Errata for the  
PCI Express<sup>®</sup> Base Specification  
Revision 2.0

**February 27, 2009**

REVISION	REVISION HISTORY	DATE
	Initial PCI-SIG release. Errata A1-A57, B1-B35, and C1-C38	07/07/2008
	Second release. Added Errata A58-A63, B36-B59, and C39-C41	02/27/2009

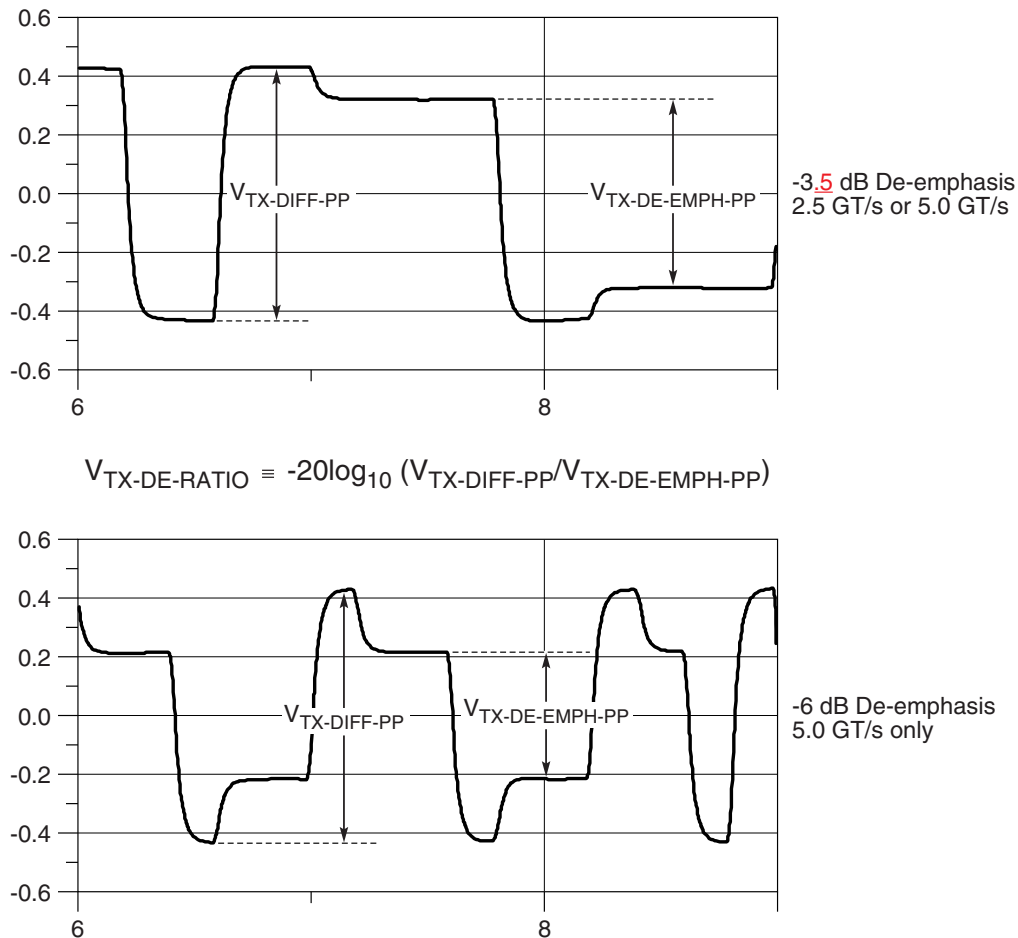
In Section 4.2.6.3.2.1, page 206, line 14, make the following edit:

- The assigned non-PAD Lane numbers must range from 0 to n-1, be assigned sequentially to the same grouping of Lanes that are receiving the same Link number ~~Lane numbers~~, and Downstream Lanes which are not receiving TS1 Ordered Sets must not disrupt the initial sequential numbering of the widest possible Link. ...

Figure 7-13: Device Control Register

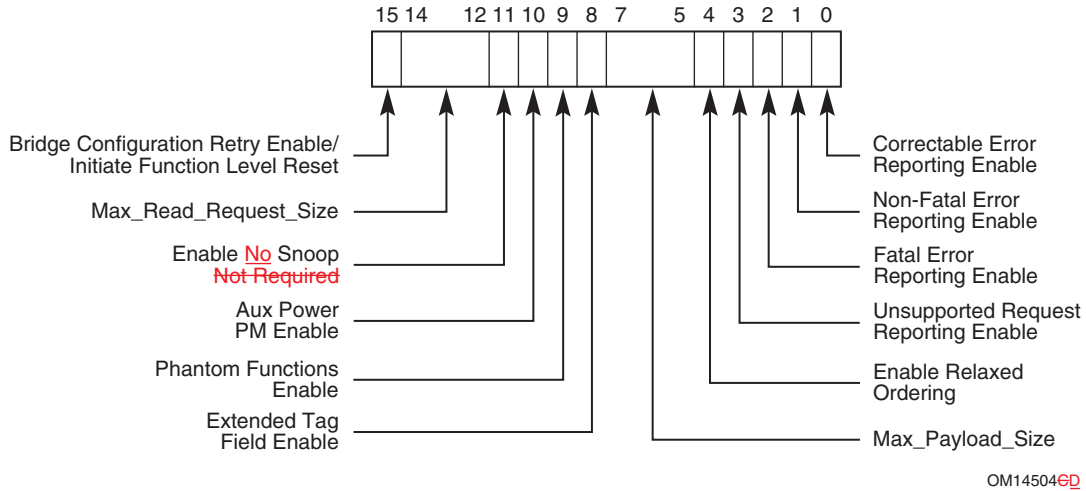
## B24 Device Control Register

In Section 7.8.4, page 449, Figure 7-13, make the following edit:

Figure 2-10: Transaction Descriptor

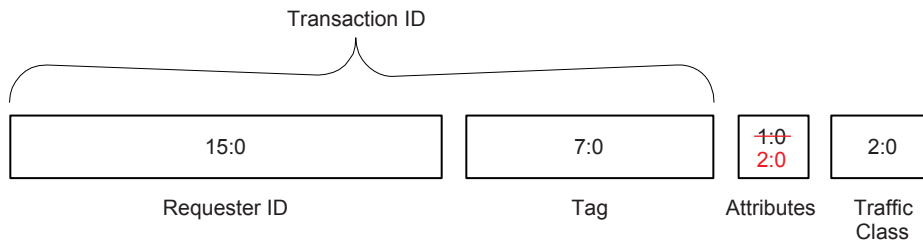
Modify Figure 2-10 Transaction Descriptor as shown:

Figure7-16: Link Control Register

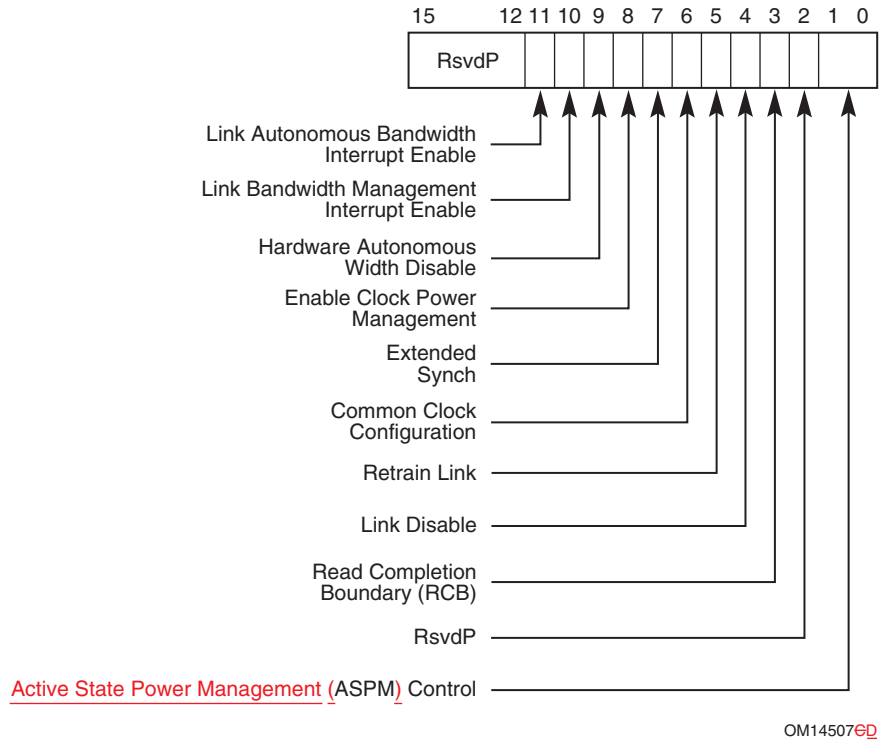
## C16 Link Control Register

In Section 7.8.7, page 462, Figure 7-16, make the following edit:

Figure 7-66: Root Complex Link Control Register

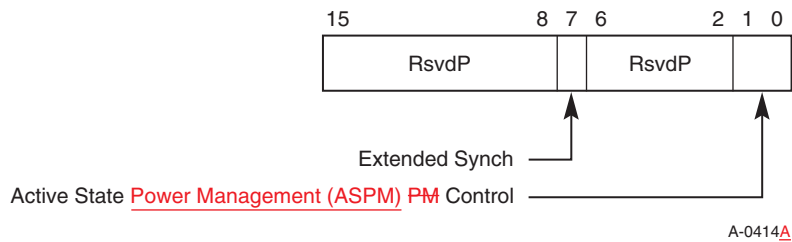
## C17 Root Complex Link Control Register

In Section 7.14.3, page 538, Figure 7-66, make the following edit:
